CONNECTOR FEATURES	
PRODUCT TYPE	M12 A-CODED FIELD ATTACHABLE
CONTACT TYPE	FEMALE
NUMBER OF CONTACTS	8POLES
HOUSING TYPE	90°
EXIT CABLE	PG7
RATED VOLTAGE	30V AC/DC
RATED CURRENT	2A
COUPLING NUT MATERIAL	Brass+nickel plated (CuZnNi)
HOUSING MATERIAL	PA66 - CM3004V0
INTERNAL CORE MATERIAL	PA66 - CM3004V0
O"RING	NBR
PROTECTION CLASS	IP65/IP67
CONNECTOR WITH H.T.P.LOGO

TOLLERANZE ±0.2	DISEGNATORE LORENZO CIMMINO	DATA 07.08.14	SCALA 1:1		DISEGNO 1/2
U.d.M / ANGOLO	CONTROLLATO				
DESCRIZIONE: M12 FEMALE ANGLED 90°,8POLES, FIELD ATTACHABLE. CONNECTOR MAIN REFERENCE NORM ATEX94/9/CE		TIPO: M12			MATERIALE
H.T.P. HIGH TECH PRODUCTS		CODICE: 12FB8000-ATEX

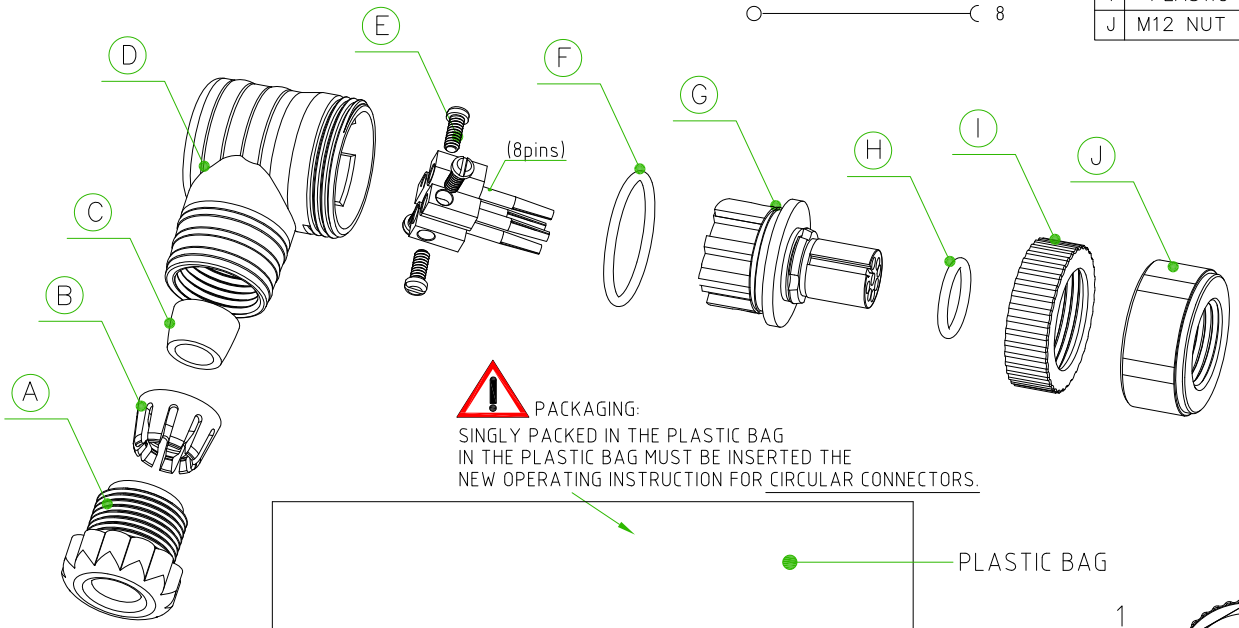
DATE	REV.	DESCRIPTION	NAME
13.10.2014	01	On the connector housing must be changed the silk print and the ATEX logo. On the label of the plastic bag must be changed the silk print and the ATEX logo. See the drawing	LORENZO CIMMINO
21.04.2020	02	Updated ATEX housing silk print, updated label and operating instruction sheet for ATEX	ROBERTO SUGLIANI

PLASTIC BAG

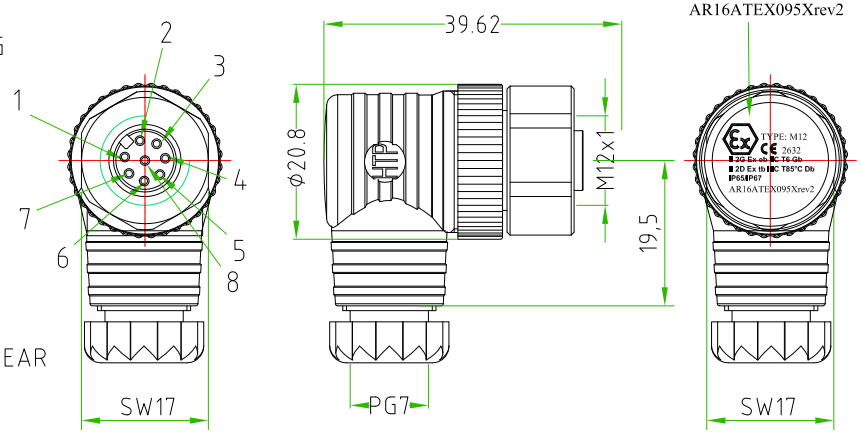
REV.02

REV.02

TYPE: M12
2632
II 2G Ex eb IIC T6 Gb
II 2D Ex tb IIIC T85°C Db
IP65/IP67
AR16ATEX095Xrev2

H.T.P. S.r.l.
I-24030 - BREMBATE DI SOPRA(BG)
CODE: 12FB8000-ATEX YEAR:20##
M12 PLASTIC HOUSING
5######
MADE IN CHINA
2632
II 2G Ex e IIC T6 Gb
II 2D Ex tb IIIC T85°C Db IP65/67
AR16ATEX095Xrev2
